ITEM 10. DEVELOPMENT APPLICATION: 106-116 EPSOM ROAD ZETLAND**FILE NO: D/2015/913****DEVELOPMENT APPLICATION NO: D/2015/913****SUMMARY**

Date of Submission:	1 July 2015, amended plans were received on 19 February 2016, 15 March 2016, 17 May 2016 and 6 July 2016.
Applicant:	Mecone Pty Ltd
Architect:	MHN Design Union and Neeson Murcutt, Architectus and BVN
Developer:	Lincon
Owner:	Lincon Development Pty Ltd
Cost of Works:	\$168,346,960
Proposal Summary:	<p>Stage 2 DA for the demolition of the existing structures, site remediation, removal of 41 trees on site, construction of a mixed use development comprising 5 buildings ranging between 5 and 14 storeys, accommodating 546 residential apartments and 1,041sqm of retail premises and the excavation of 2 levels of basement. The application involves landscaping and public domain works, the construction of parts of George Julius Avenue, Rose Valley Way, Peters Street and Letitia Street, subdivision of development lots and dedication of roads and the northern part of the lot to form part of Gunyama Park.</p> <p>The application is classified as Integrated Development as the works require approval under the Water Management Act 2000.</p> <p>T

Figure 49 – Proposed Building B (southern, Rose Valley Way elevation) demonstrating breach of 18m height control (from new public domain ground floor level)

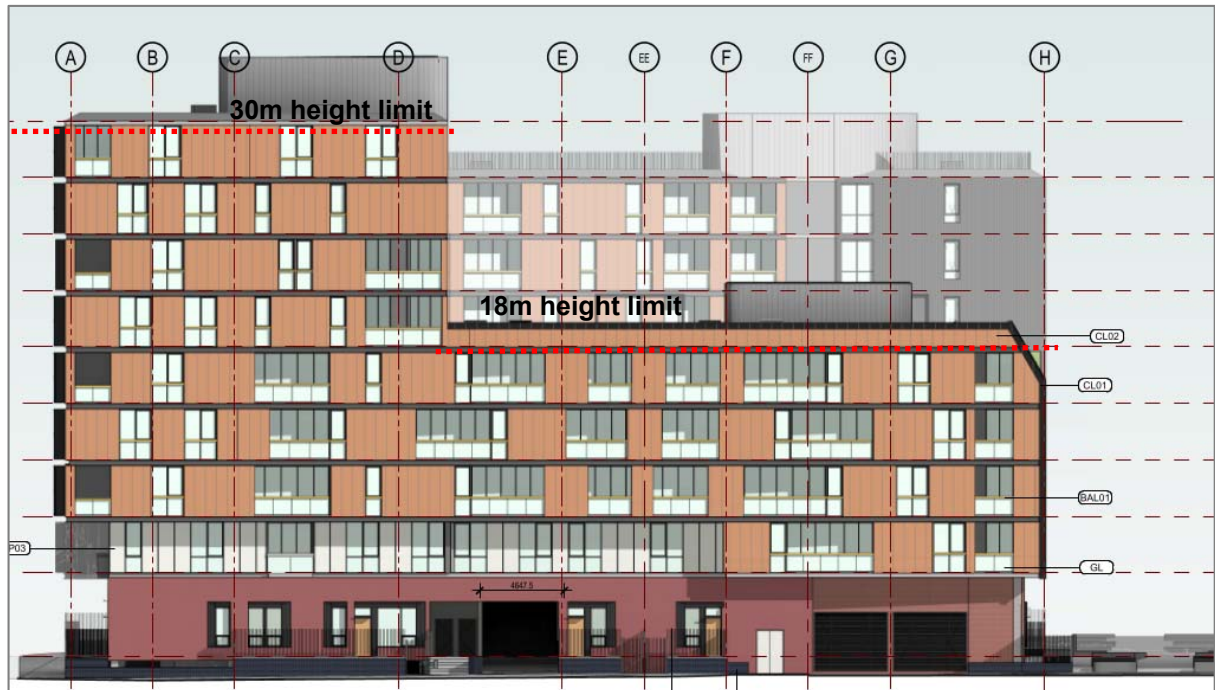
106. The part of Building B fronting Rose Valley Way exceeds the 18m height limit by part of the top floor, communal open space structures and the lift overrun by a maximum of 2m (11%) taken from existing ground level. **Figure 49** shows the exceedance of the height limit based on the new ground level public domain levels.

Figure 55 – Building B Level 8 – showing area of additional storey to Building B

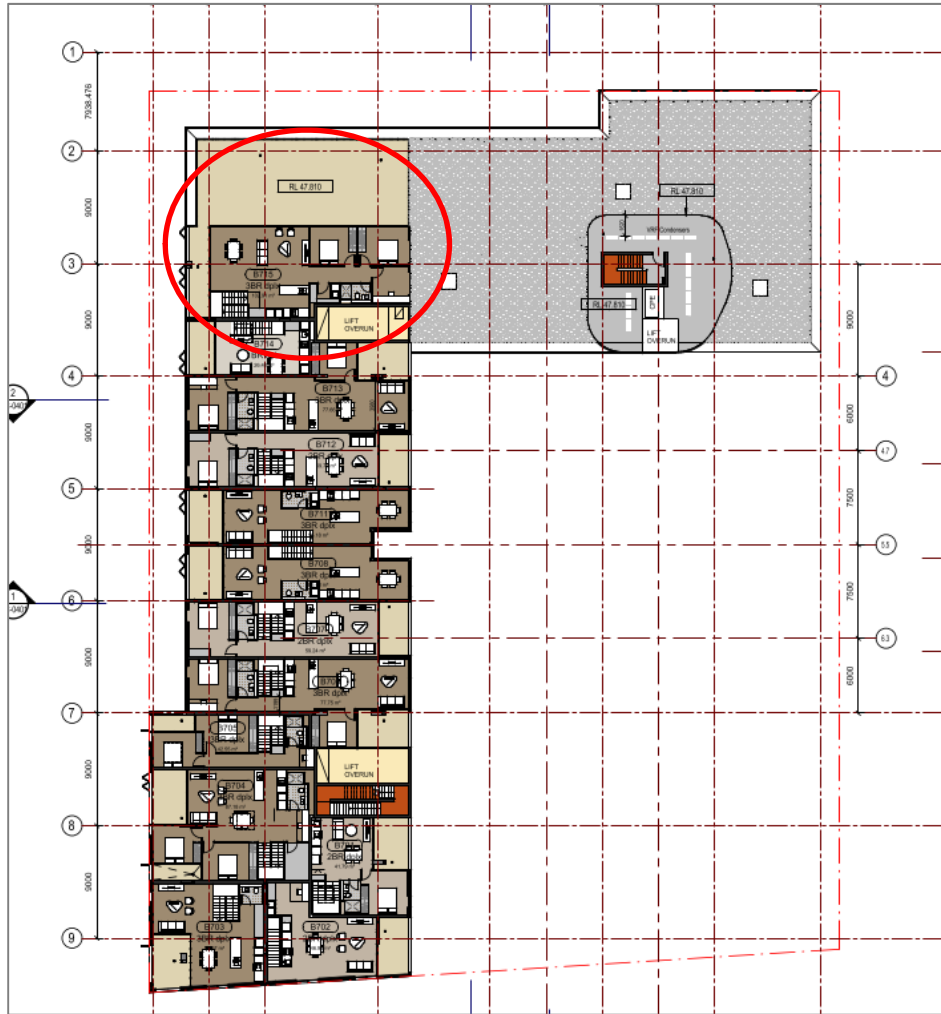
130. The northern part of Building B, fronting Peters Street is subject to a 7 storey height control under the Sydney DCP 2012, however the Stage 1 DA approved 8 storeys in this location.
131. The western part of Building B along George Julius Ave is subject to a 9 storey height control under the Sydney DCP 2012 and the Stage 1 DA.
132. The northern part of Building has been partially increased from 8 to 9 storeys on the north western corner as shown in **Figures 55 and 56**. The partial height increase allows for a continuous 9 storey building line along the George Julius Avenue. The additional storey is recessed from Peters Street and incorporates light coloured panels which reduces the appearance of bulk and scale. The additional height will not result in any overshadowing or other amenity impacts and is acceptable.

Figure 58 – Part Level 2 plan of original Building A (prior to amendments) – bedroom to lightwells and through site link circled

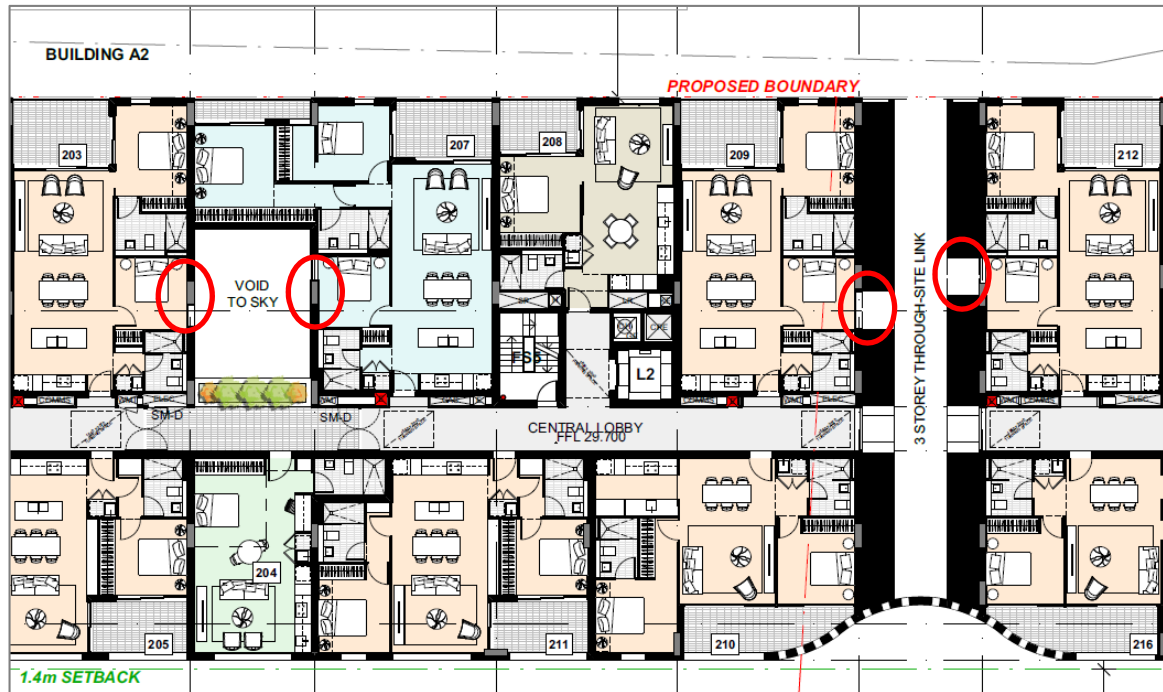
147. Building A as originally submitted relied on the use of slots to break the building mass. While the slots remained open to the southern elevation, they were largely enclosed on the northern elevation, by bedrooms and balconies bridging across the voids. This internalised the slots and created lightwells. These lightwells were the sole source of amenity to over 40 bedroom and were relied on for providing natural cross ventilation to many units. The original proposal also included 4 bedrooms with windows to the through site link. An example of this original arrangement is shown at **Figure 58**.

Figure 61 – Building A Part Level 1 plan showing internalised slot

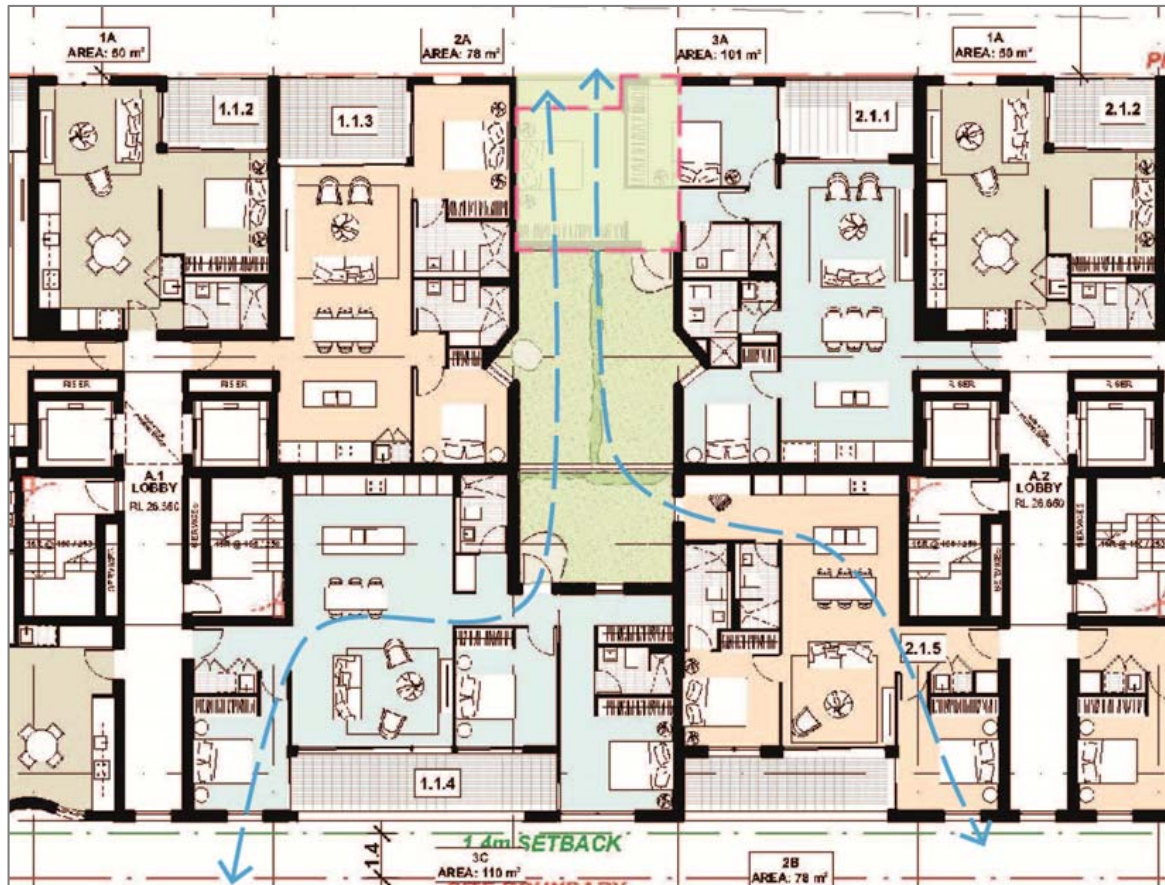
148. The enclosed slots also resulted in the building reading predominantly as a single tower form, particularly on its northern side, rather than 3 separate tower elements.
149. Amended plans were received in response to officers concerns in regards to the amenity of the bedrooms to the enclosed slot (light, outlook privacy and acoustic privacy), the reliance on the enclosed slots to achieve natural cross ventilation and the urban design outcome on the northern elevation with the building reading as a single form.
150. The amended plans, which are the subject of this assessment, address the majority of the issues, however there are still two internalised slots on level 1 and 4. A condition is recommended to remove the 3rd bedroom to unit 2.1.1 on level 1 and unit 2.4.1 on level 4 as shown crossed on **Figures 59 and 60**.

151. The removal these two bedrooms will improve the outlook for the four bedrooms with outlook onto the slots. The removal of these two bedrooms will also allow four more units to achieve natural cross ventilation – units 1.1.4 and 2.1.5 on level 1 as shown in **Figure 61**, and in the same way to units 1.4.4 and 2.4.5 on level 4.
